# TMC SPECIFICATION

NO. S 1179

TITLE: **200K Improvement Modifications**

TITLE: *to* GPT 200K (AN/FRT-62) Improvement Modifications.

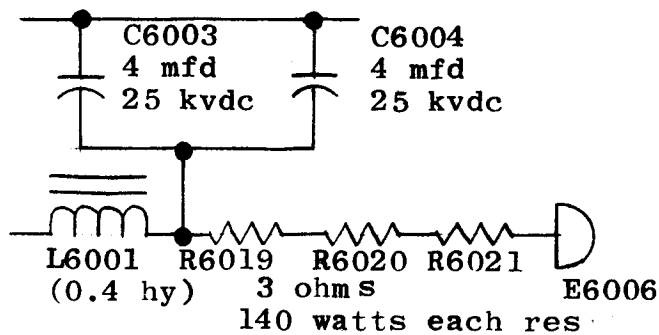
3. After high voltage wiring has been installed wrap teflon sheeting, cut to size around each high voltage (Item 10) transformer secondary terminal, with glass tape. (Item 9.)

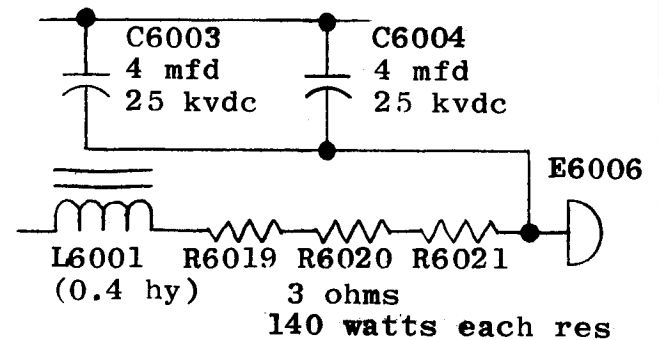
4. Remove the connection from High Voltage Capacitors going from C6003 and C6004, (4 mfd 25 kvdc) to the tiepoint of choke L6001 and R6019.

5. Connect a new lead with teflon sleeving, to go from C6003/C6004 tiepoint to terminal E6006 and R6021, R6018 tiepoints.

7. Make pen and ink diagram changes as shown:

**BEFORE MODIFICATION:**

**AFTER MODIFICATION:**

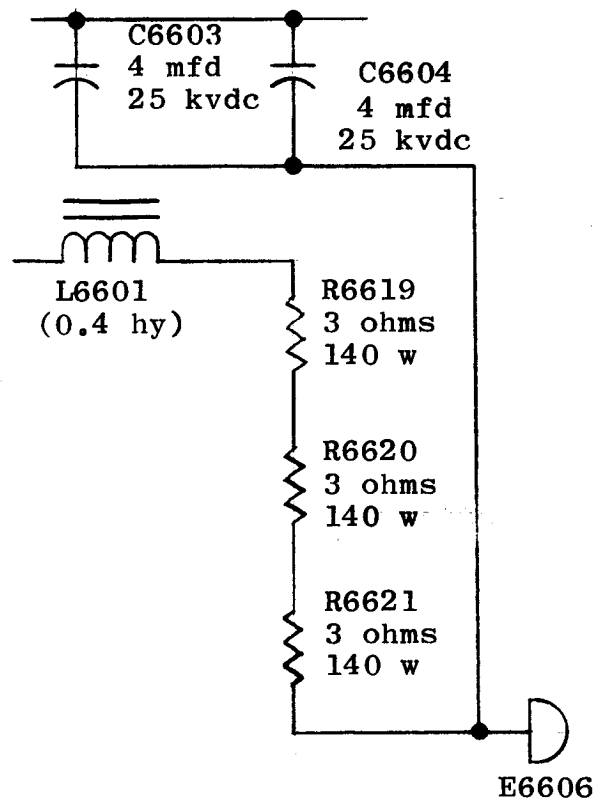
A. Remove the connection from high voltage capacitors going from C6603/C6604, (4mfd 25kvdc) to the tiepoint of choke L6601 and R6619.

B. Connect a new lead with teflon sleeving, to go from C6603/C6604 to the tiepoint of terminal E6606 and R6621, R6618.

D. Make pen and ink diagram changes as shown:

#### BEFORE MODIFICATION:

#### AFTER MODIFICATION:

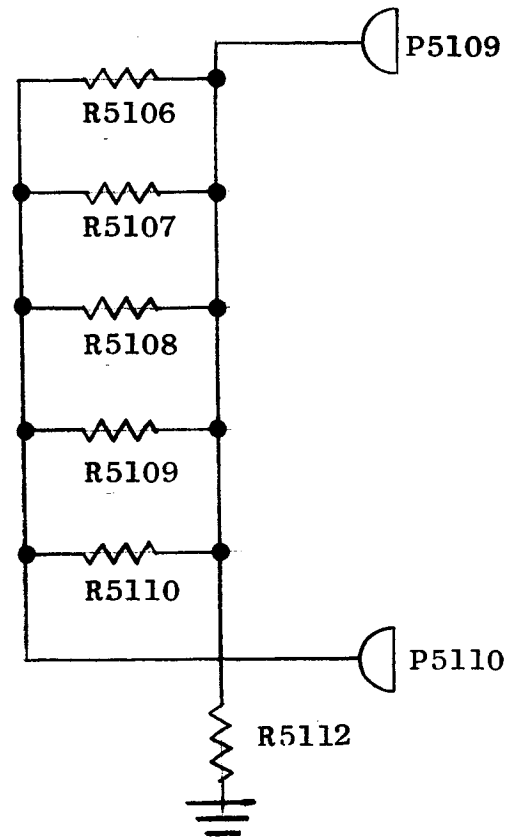
3. Upon the location of R5111, remove the connection going to R5105/P5110. Relocate this connection to R5106/P5109 tiepoints.

4. Upon the location of R5112, remove the connection going to R5110/P5108. Relocate this connection to R5101/P5107 tiepoints.

6. Make the following changes to schematics as shown: Substitute Symbol numbers for Alpha Bias supply schematic ~~changes shown~~

BEFORE: (Bravo Bias  
Unit Shown only)

AFTER: (Bravo Bias  
Unit Shown only)
